DOCUMENT CHANGE REQUEST

DCR number 386	Changes required for: General	Originator: S Jeffery
Date: 2007/10/24	Date sent: 2007/10/24	Organisation: ESA/ESTEC
Status: IMPLEMENTED

Title:	Transistors Field-Effect N-Channel, based on types 2N4416 and 2N4416A		
Number:	5205/004	Issue:	1

ESCC Detail Specification No. 5205/004

1.6.1 Metal Can Package (TO-72) - 4 lead

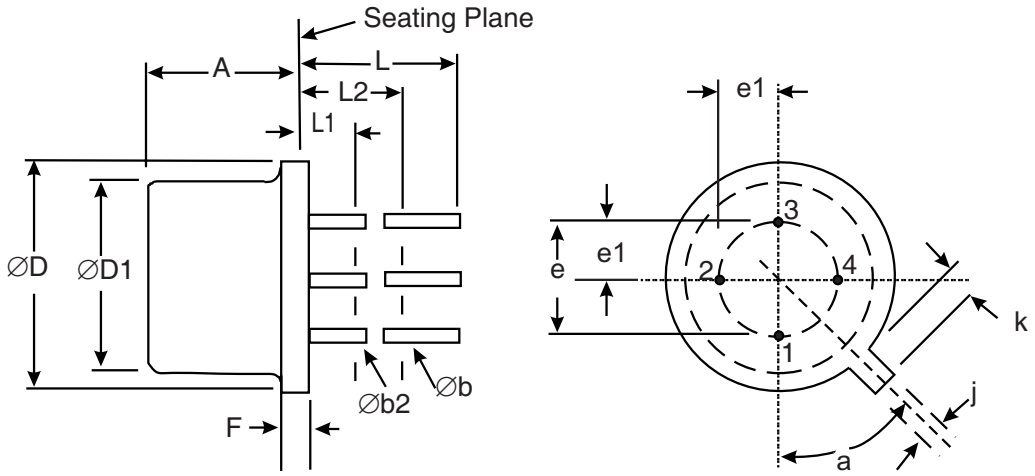
7. Figure 2 re-named "Physical Dimensions and Terminal Identification"; Notes revised (addition of Note 1 about Terminal Identification and Note 2 "applies to all leads" for dims. 'Ã.b', 'Ã.b2', 'L', 'L1' and 'L2').

1. Terminal identification is specified by reference to the tab position where lead 1 = source, lead 2 = drain, lead 3 = gate and lead 4 = connected to the case.
2. Applies to all leads.
3. Øb2 applies between L1 and L2. Øb applies between L2 and 12.7mm from the seating plane. Diameter is uncontrolled within L1 and beyond 12.7mm from the seating plane.
4. Measured from the maximum diameter of the actual device.
5. Leads having maximum diameter 0.483mm measured in the gauging plane 1.37(+0.025,-0)mm below the seating plane of the device shall be within 0.178mm of their true position relative to a maximum-width-tab.
6. Measured from the tab centreline.

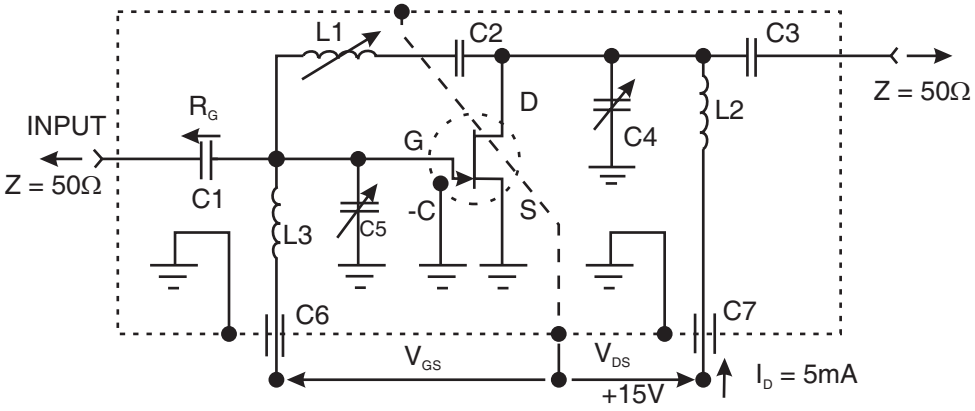
22. Figure 4(a) corrected and moved to be a note (Note 3) to Room Temperature Electrical Measurements.

1. Pulsed measurement: Pulse Width ≤ 300µs, Duty Cycle ≤ 2%.
2. For AC characteristics read and record measurements shall be performed on a sample of 32 components with 0 failures allowed. Alternatively a 100% inspection may be performed.
3. Small-signal common-source insertion power gain (neutralised) and noise factor shall be measured using the following test circuit.
